CAP MEETING – 9 NOVEMBER 2022
ITEM 8.1

DEVELOPMENT NO.:	22002690
APPLICANT:	Anthony Rinaldi
ADDRESS:	LOT 720 (16A) WHITE AV CRAFTERS 5152
NATURE OF DEVELOPMENT:	Two storey detached dwelling, swimming pool & associated safety barriers, retaining walls (maximum height 1.4m) and removal of a Significant tree (<i>Populus deltoids</i> - Cottonwood)
ZONING INFORMATION:	<p>Zones:</p> <ul style="list-style-type: none"> • Rural Neighbourhood <p>Subzones:</p> <ul style="list-style-type: none"> • Adelaide Hills <p>Overlays:</p> <ul style="list-style-type: none"> • Hazards (Bushfire - Medium Risk) • Hazards (Flooding - Evidence Required) • Mount Lofty Ranges Water Supply Catchment (Area 2) • Native Vegetation • Prescribed Water Resources Area • Regulated and Significant Tree • State Significant Native Vegetation • Traffic Generating Development <p>Technical Numeric Variations (TNVs):</p> <ul style="list-style-type: none"> • Minimum Site Area
LODGEMENT DATE:	7 Apr 2022

RELEVANT AUTHORITY:	Assessment Panel at Adelaide Hills Council
PLANNING & DESIGN CODE VERSION:	2022.6
CATEGORY OF DEVELOPMENT:	Code Assessed - Performance Assessed
NOTIFICATION:	Yes
RECOMMENDING OFFICER:	Doug Samardzija Senior

DRAWING TITLE			
SECTIONS & DETAILS			
ENGINEER	M. ZANATTA	STATUS	FOR PLANNING APPROVAL
SCALES	1:250	PROJECT No.	220505
SURVEYED	BY OTHERS	SHEET SIZE	A1
		DRAWING No.	C4
		ISSUE	P1

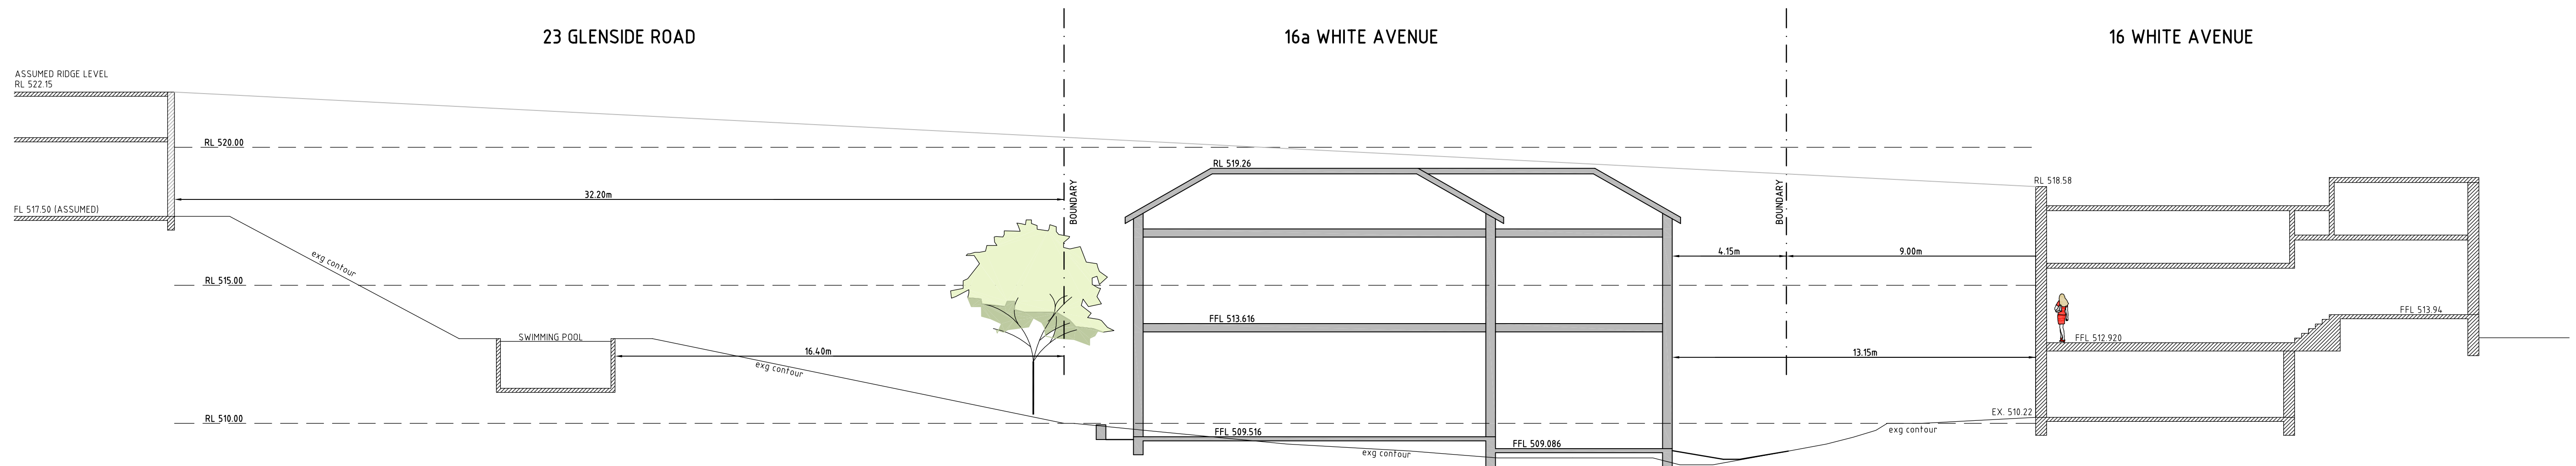
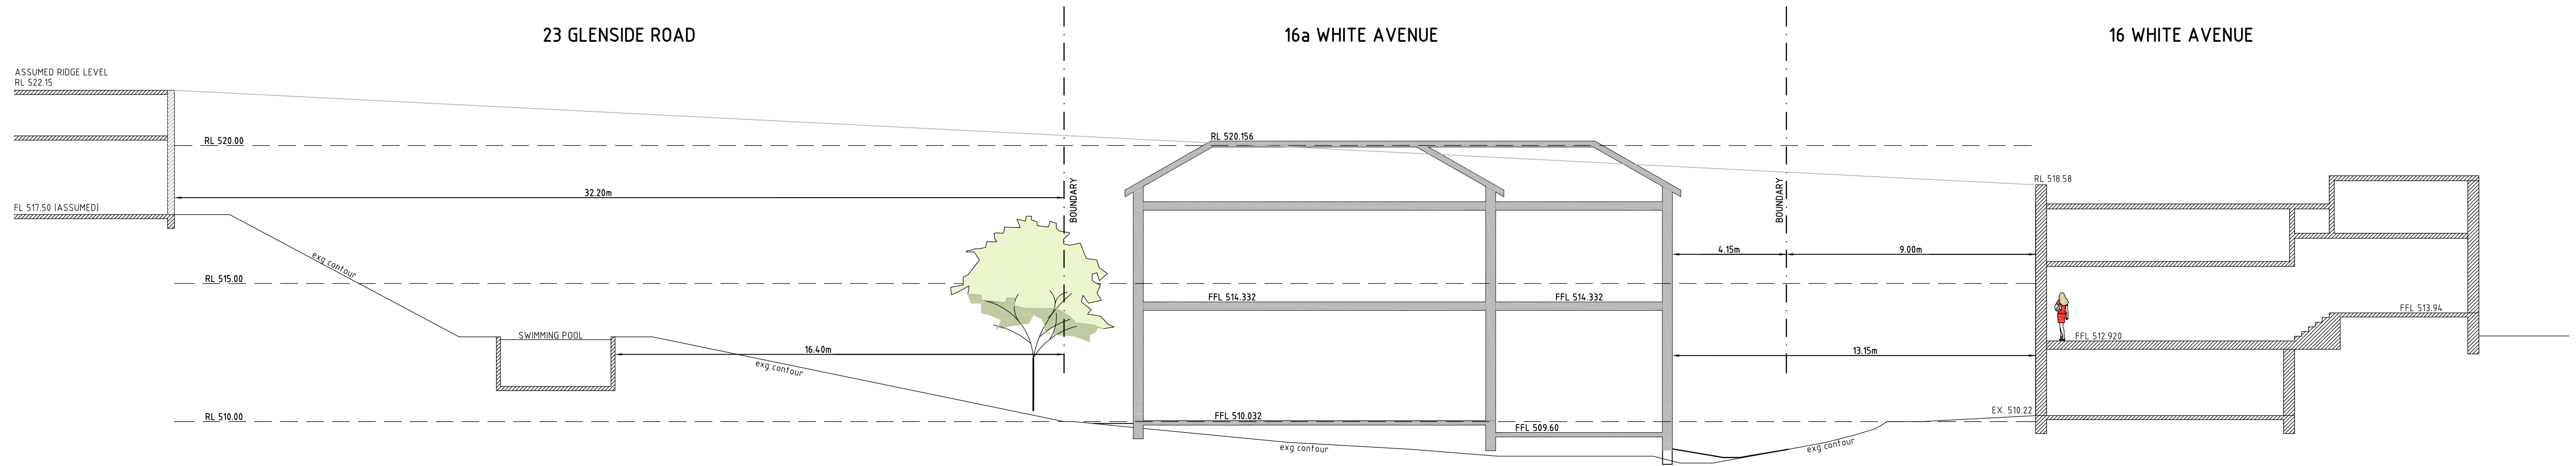
SECTION - LOWERED FLOOR LEVEL 3 C1
1:125

SECTION - ORIGINAL FLOOR LEVEL 3 C1
1:125

DRAWING NO: **SK07**

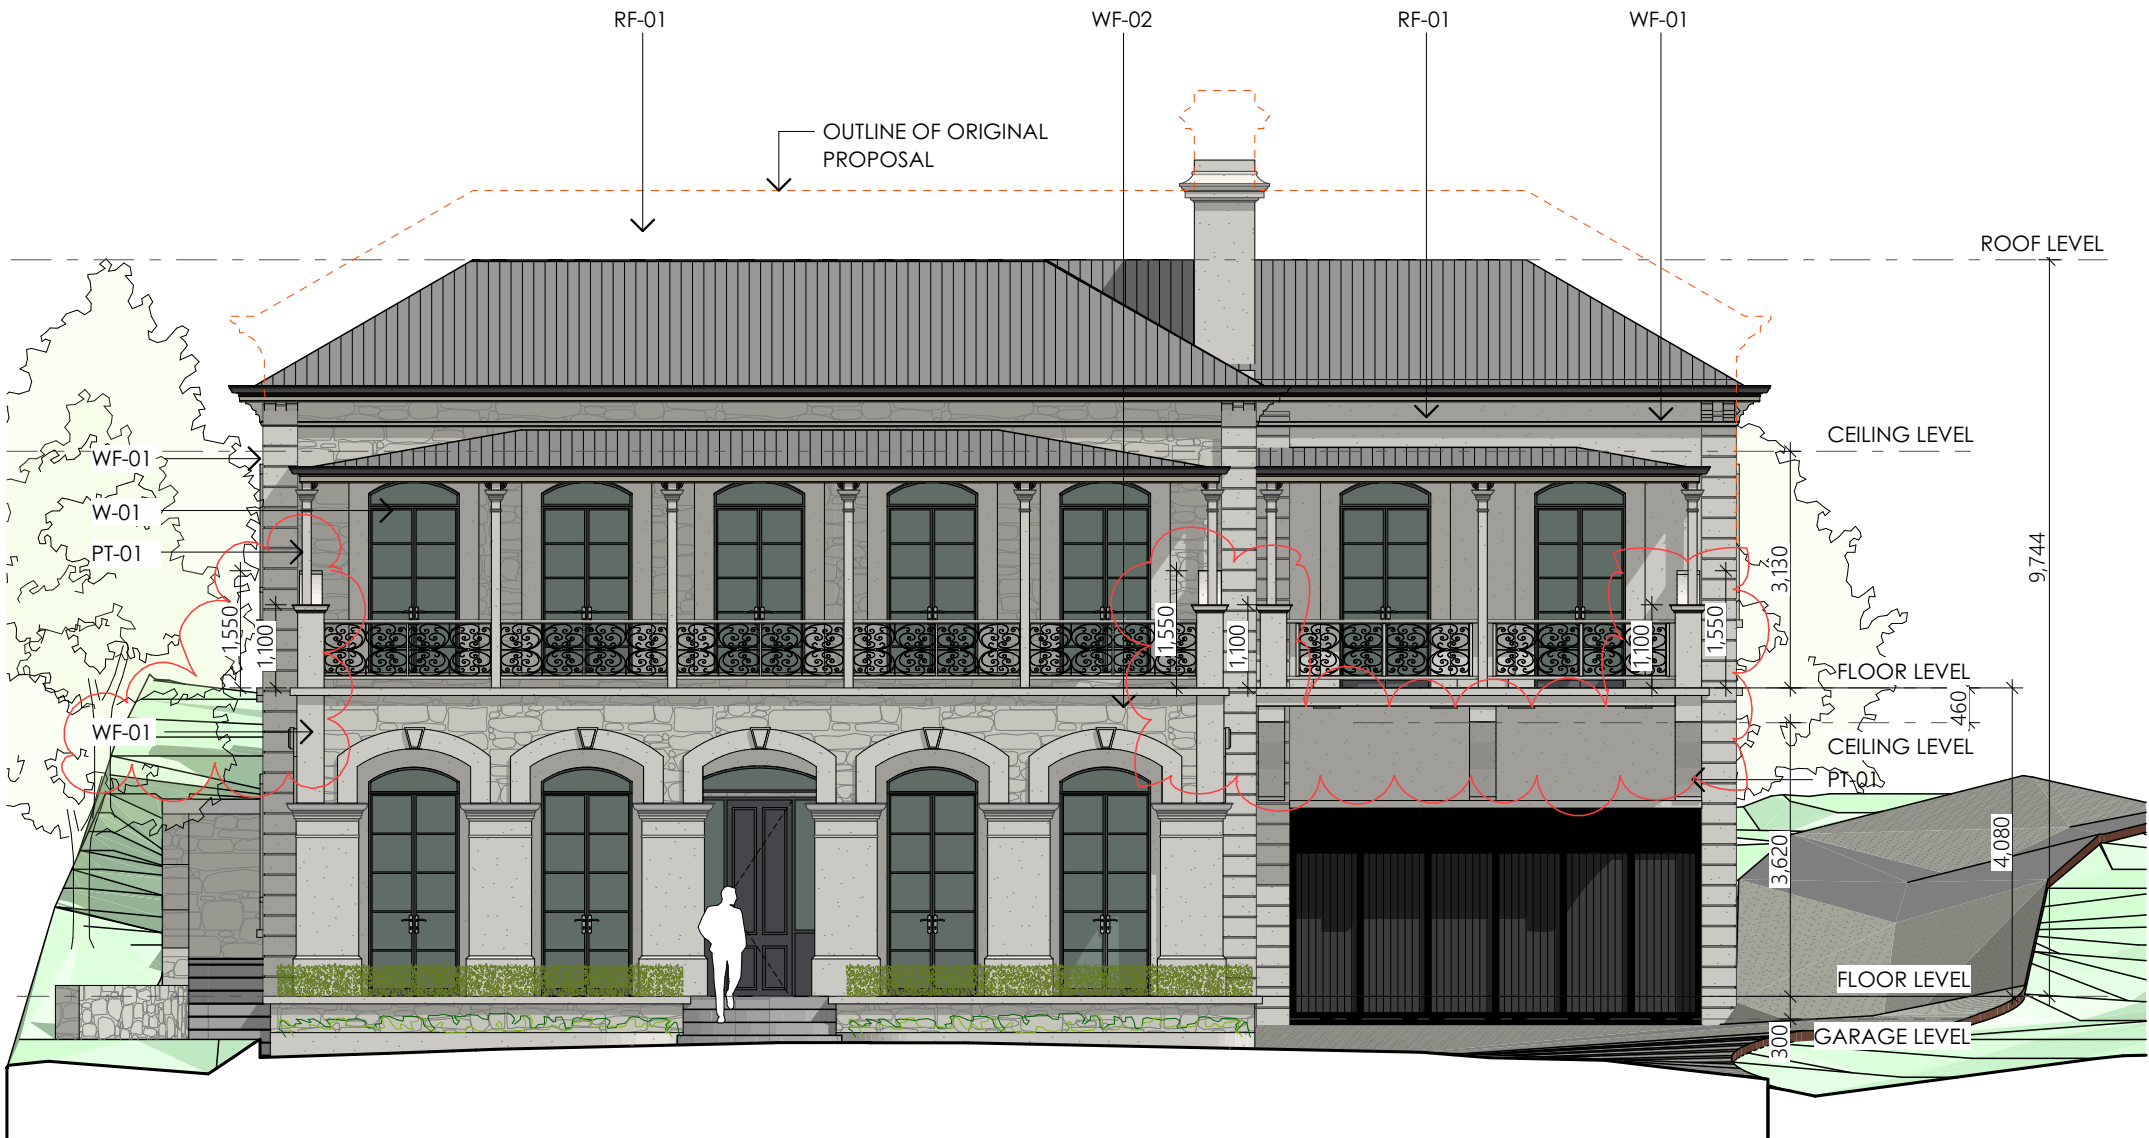
The proposed dwelling exceeds these heights in small portions of its form that are restricted to the eastern most points of the building. Drawing SK07 demonstrates that the majority of the dwelling lies beneath the 9.0-metre building envelope when measured from natural ground level. It can therefore be seen that the minimal exceedance of this is a function of the topography of the site, which slopes towards the east.

Figure 1 | Section Lower Floor Level

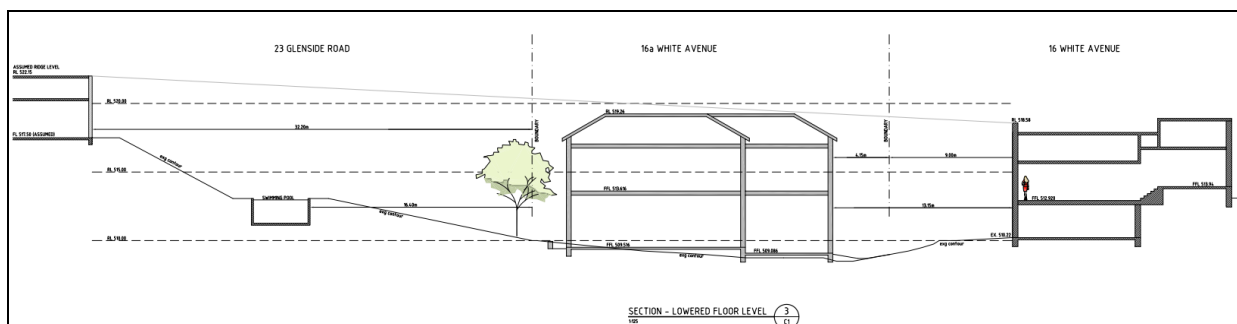
In practical terms, the lower level of the two storey portion of the dwelling is now sited considerably lower than natural ground level for a substantial portion of the western elevation. As it relates to the land to the west, and as shown in Figure 1, the majority of windows at the lower level will look into a retaining wall and screening vegetation to be planted along the boundary.

Refer MQZ Consulting Engineers drawing C4 provided in **Appendix B**.
